CLARK
BARNES

MUP REVISION

323 BELLEVUE AVE E, SEATTLE, WA 98102

PROJECT #:3037110-LU

SOUTH ELEVATION COMPARISON

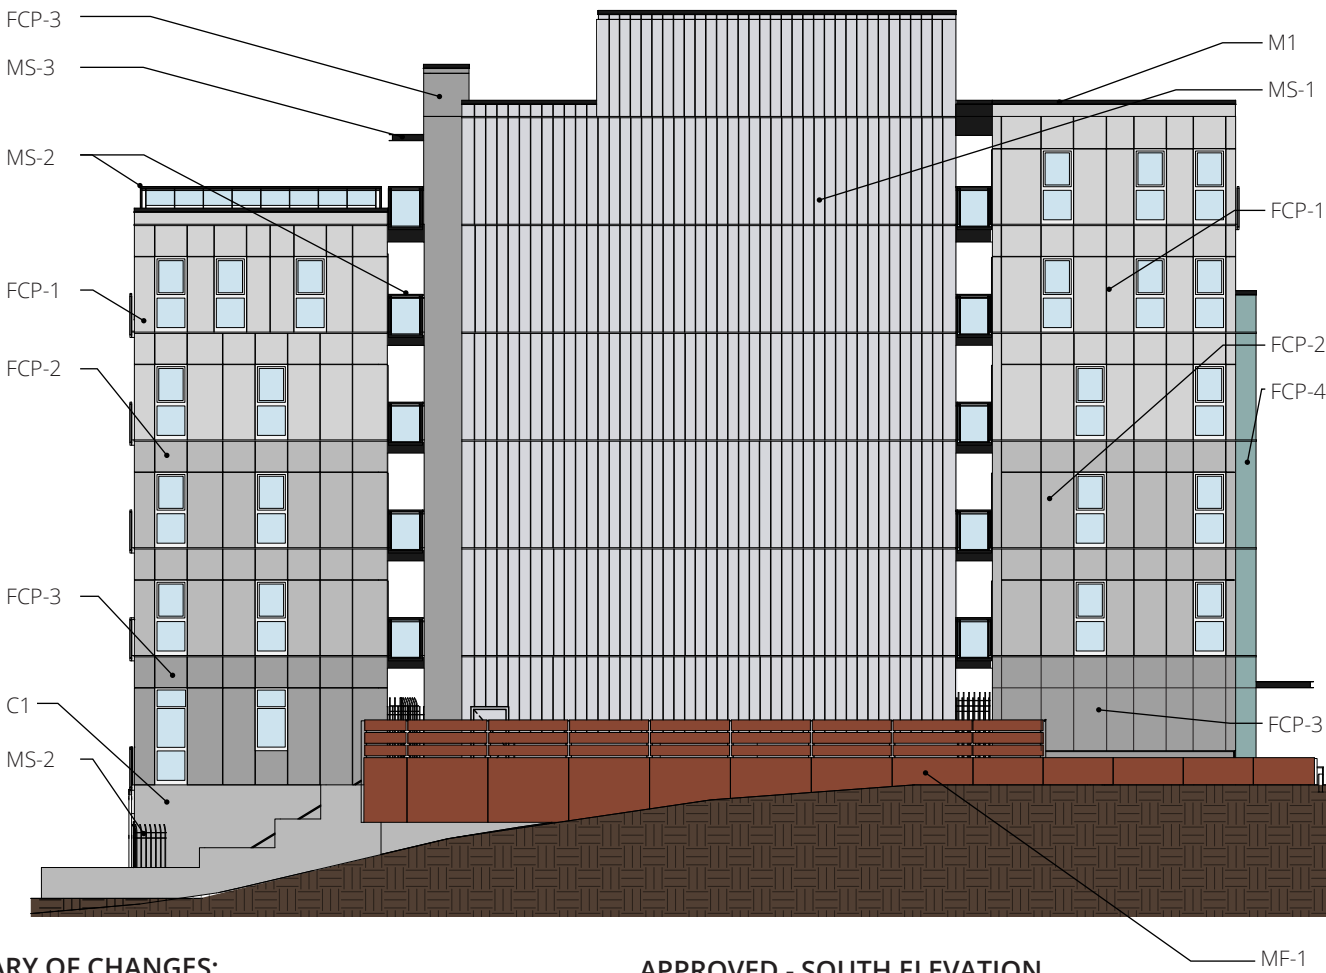
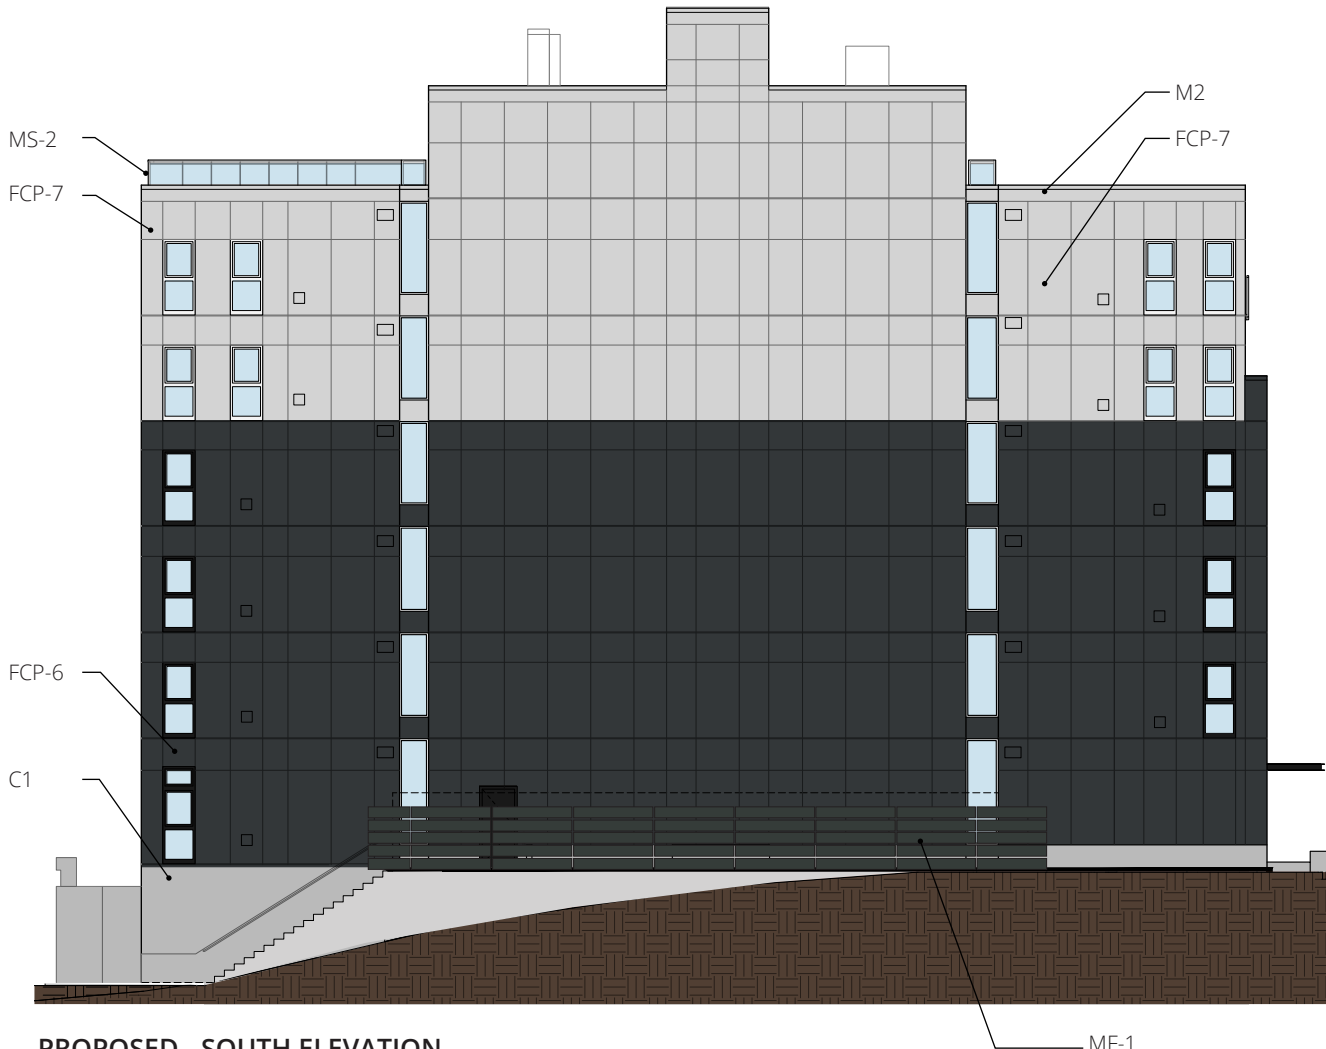
- Material and color palette simplified. Previous metal siding is eliminated, bringing the project into alignment with the Capitol Hill Design Guidelines and the boards comments at EDG 2, which specifically discourages use of metal siding (**Previously DC4-II-i**).

- Entry fin is more successfully integrated into the simplified facade, appearing as a continuation of the 4-story siding base rather than previous 'tacked on' element. **[DC4.1]**

- Southern facade jog straightened out to simplify massing and provide a clear, 3-part facade punctuated by the visually open corridor endings. **[CS3.A.2]**

- Fence material updated to dark-stained wood to better align with muted/simplified color palette and reduce visibility of the security element. **[PL3.B.1 & DC4.1.c]**

- Two units were added to the 6th floor (west end), bringing the project into better alignment with current MHA zoning. **[Note: under current zoning, an entire 7th floor and 20' of height could be added to the project] [CS2.D]**

- Rooftop penthouse size/height was increased to provide code-compliant accessibility for all residence to the rooftop amenity. The rooftop area is minimally visible from the sidewalk. **[PL2.1]**

WEST / ALLEY ELEVATION COMPARISON

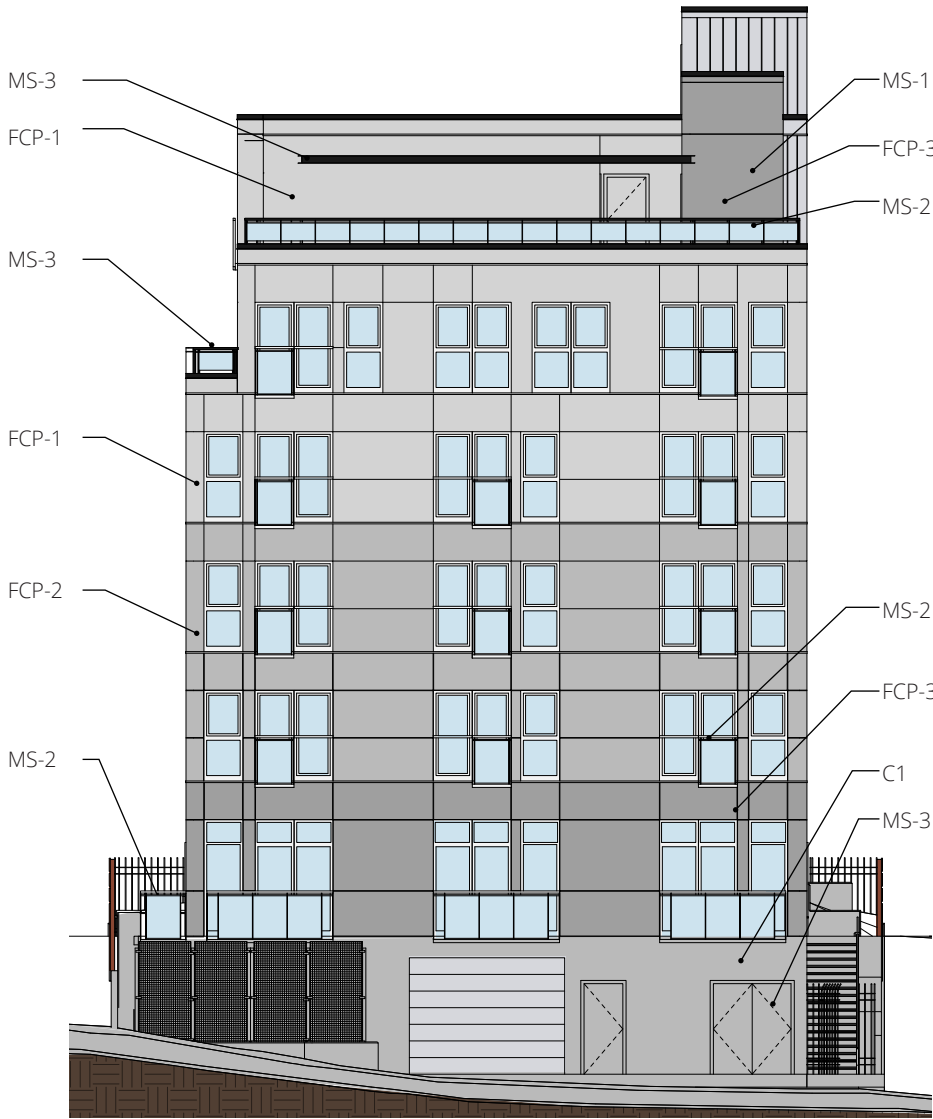
- Material and color palette simplified. The proposal responds to the adjacent 4-story buildings and continues the datum established by the 4-story brick around to the North, West & South Facades. [CS2.C.2 & CS3.1]
- Window mullion pattern is simplified to maximize transparency and views to the West. [DC1.A.4 & DC4.1]
- Garbage room's exterior access door to alley was removed, streamlining the facade and reducing visible utility doors. [DC1.C.4]
- Two units were added to the 6th floor (west end), bringing the project into better alignment with current MHA zoning. [Note: under current zoning, an entire 7th floor and 20' of height could be added to the project] [CS2.D]
- Rooftop penthouse size/height was increased to provide code-compliant accessibility for all residence to the rooftop amenity. The rooftop area is minimally visible from the sidewalk. [PL2.1]

NORTH ELEVATION COMPARISON

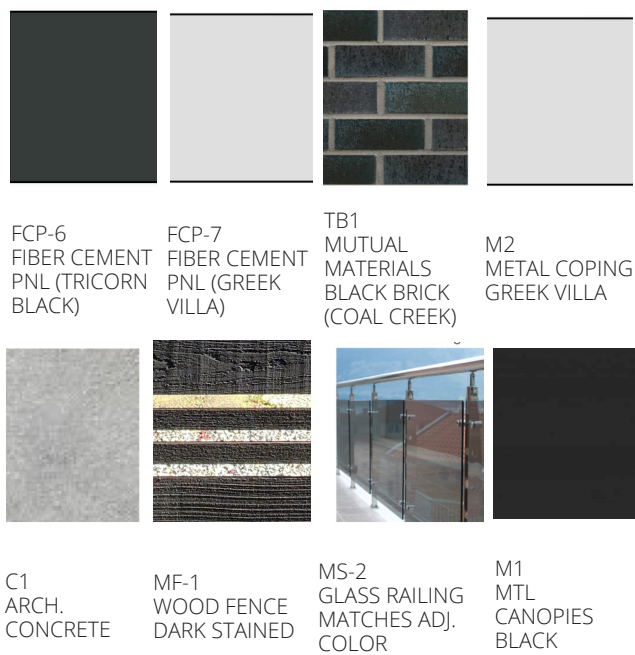
- Material and color palette simplified. The proposal responds to the adjacent 4-story buildings and continues the datum established by the 4-story brick around to the North, West & South Facades. **[CS2.C.2 & CS3.1]**
- Fence material updated to dark-stained wood to better align with muted/simplified color palette and reduce visibility of the security element. **[PL3.B.1 & DC4.1.c]**
- Two units were added to the 6th floor (west end), bringing the project into better alignment with current MHA zoning. **[Note: under current zoning, an entire 7th floor and 20' of height could be added to the project]** **[CS2.D]**
- Rooftop penthouse size/height was increased to provide code-compliant accessibility for all residence to the rooftop amenity. The rooftop area is minimally visible from the sidewalk. **[PL2.1]**

DEPARTURE REQUEST

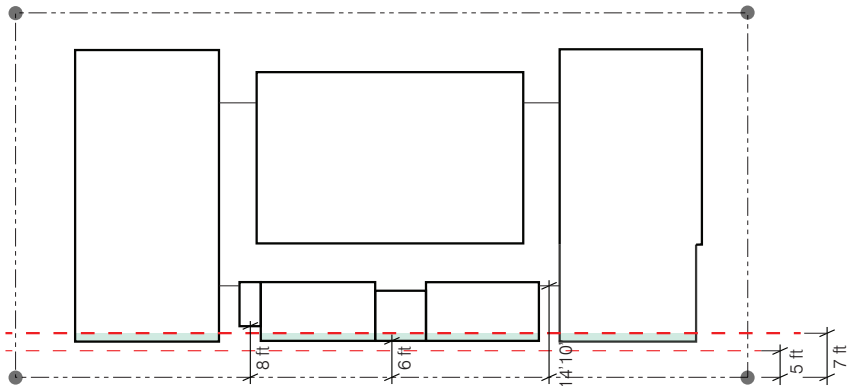
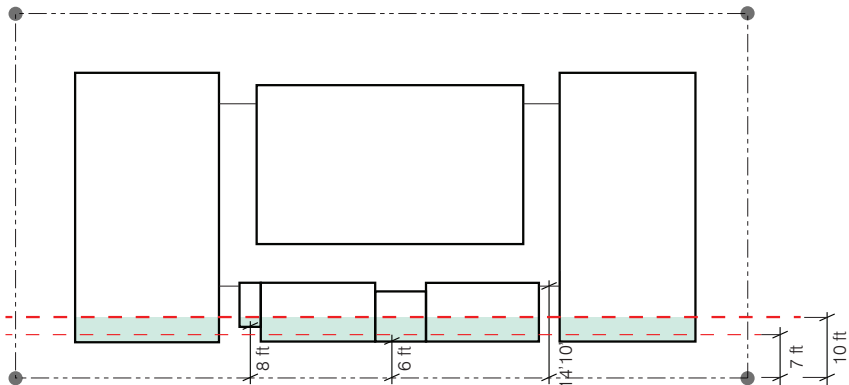
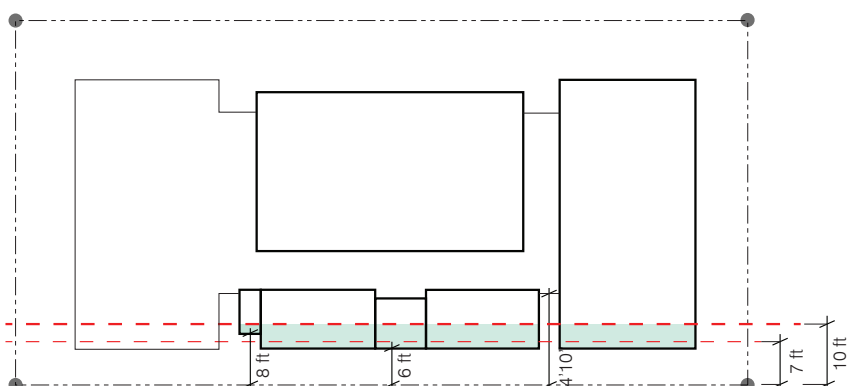
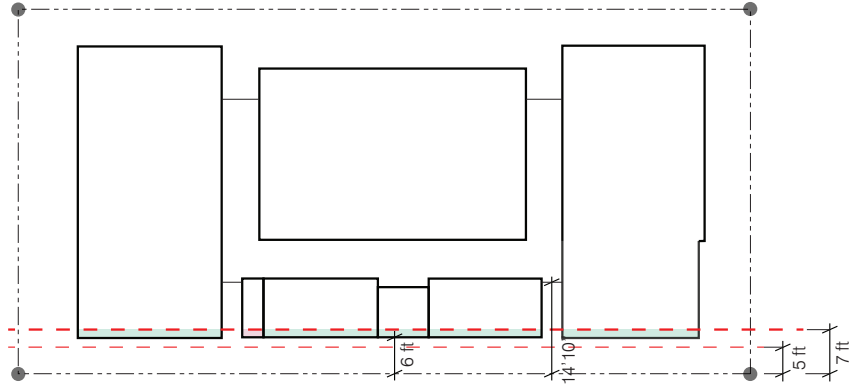
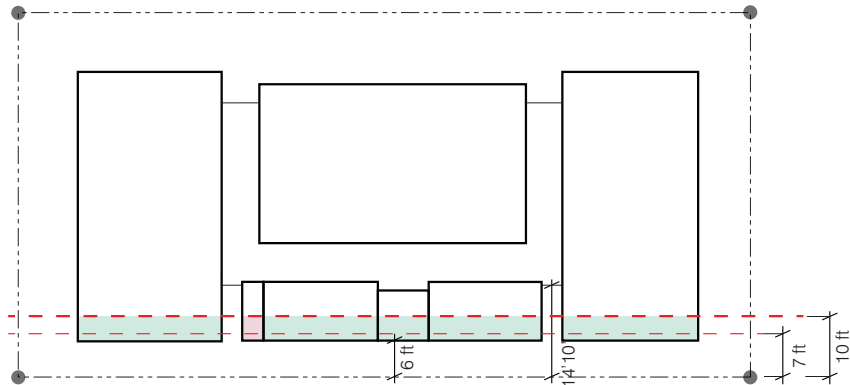
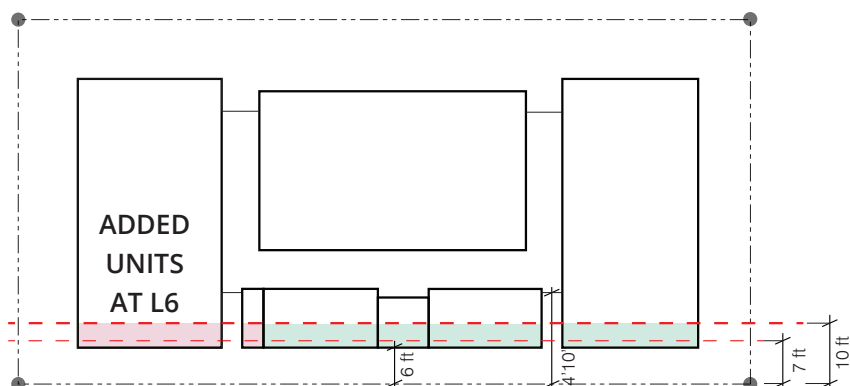
PROPOSED DEPARTURE REQUEST SETBACKS PER
MUP 3037110-LU

SOUTH ELEVATION <42FT IN HEIGHT:
REQUIRED: 7' AVERAGE REQUIRED
PROVIDED: 6.58' AVERAGE; 6' MINIMUM

SOUTH ELEVATION >42FT IN HEIGHT:
REQUIRED: 10' AVERAGE; 7' MINIMUM REQUIRED
PROVIDED: 6.59' AVERAGE; 6' MINIMUM

JUSTIFICATION:
CONSISTENT WITH MHA ZONING CHANGES THAT OCCURRED AS A RESULT OF HALA LEGISLATION, PASSED SUBSEQUENT TO ORIGINAL MUP APPROVAL, THE PROJECT ADDED TWO DWELLING UNITS TO THE TOP FLOOR AT THE REAR OF THE PROJECT. THE RESULTANT MODIFICATIONS TO THE MASSING ARE NOT VISIBLE FROM THE STREET, BUT INCREASED THE SCOPE OF THE PREVIOUSLY-APPROVED SOUTH SIDE SETBACK DEPARTURE.

ADDITIONALLY CONTRIBUTING TO THE SOUTH SETBACK AVERAGE VALUE CHANGE, A SMALL STEP IN THE FACADE IN THE MIDDLE PORTION WAS ELIMINATED, SIMPLIFYING THE MASSING AND INCREASING THE LEGIBILITY OF THE SOUTHERN FACADE AS A THREE-PART MASS SEPARATED BY TRANSPARENT CORRIDOR ENDINGS. THIS BETTER MEETS DESIGN GUIDELINE DC2-B-1 FACADE COMPOSITION.
